Perry Nuclear Power Plant  
Docket Nos. 50-440; 50-441  
Structural Engineering Branch

The Structural Engineering Branch has identified several questions concerning the design of the Perry intake and discharge cooling water tunnels. These questions were based on a previous submittal dated March 11, 1982, on the same subject.

## Responses to Additional Request for Tunnel Design

FIGURE 19. TRANSVERSE GROUND DISPLACEMENT SPECTRUM (FROM REF. 1)

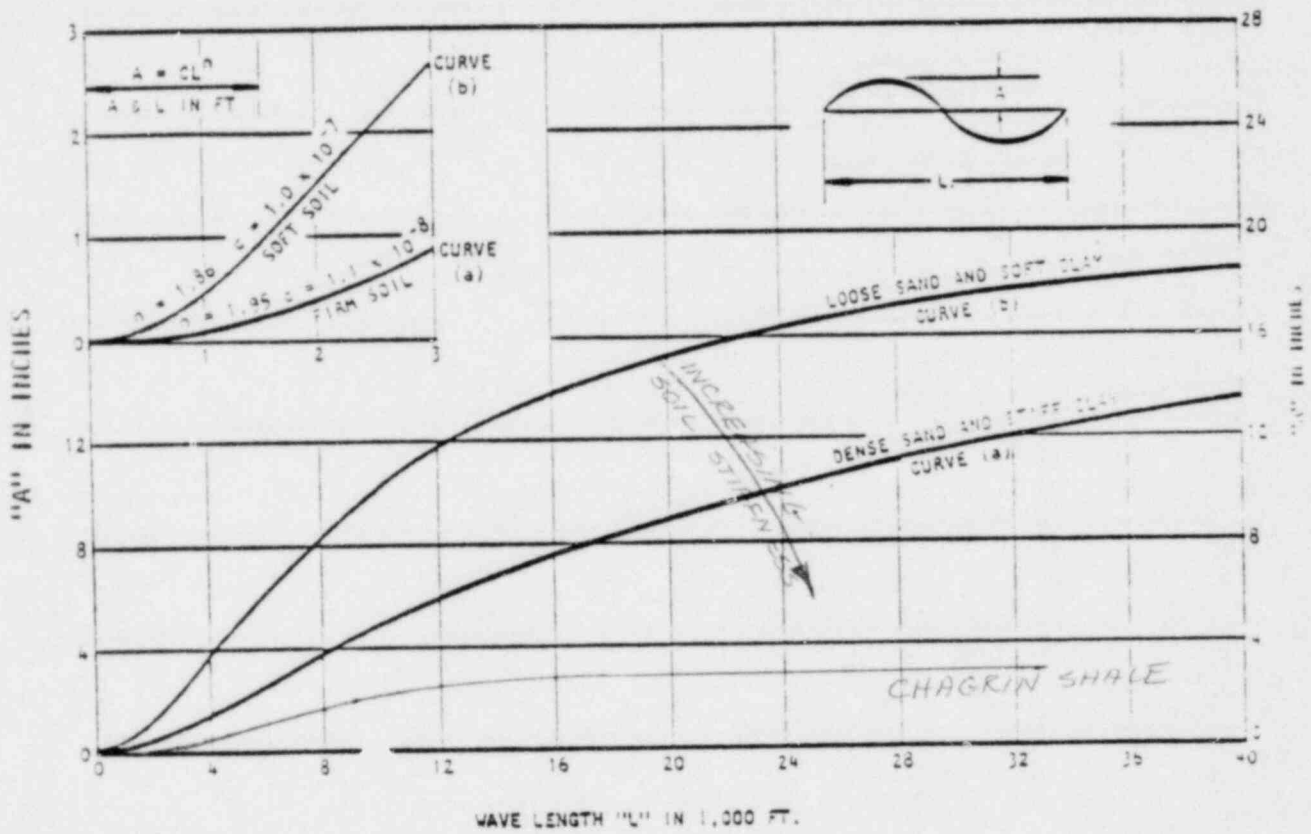
6. Reference page 24 of previous response. What is the basis for the numbers used--especially 9000 feet.

The numbers used to study the response of the tunnel in the longitudinal direction fall out of relationships developed by Kuesel (1969) and the properties of the Chagrin shale. Figure 19, attached herein, shows the relationships between wavelength and amplitude for 1) loose sand and soft clay; and 2) dense sand and stiff clay. I have drawn in the assumed curve for Chagrin shale. The curve was assumed to have the same shape as the curves developed by Kuesel but the magnitude of the wave amplitude is decreased to reflect the stiffness of the shale.
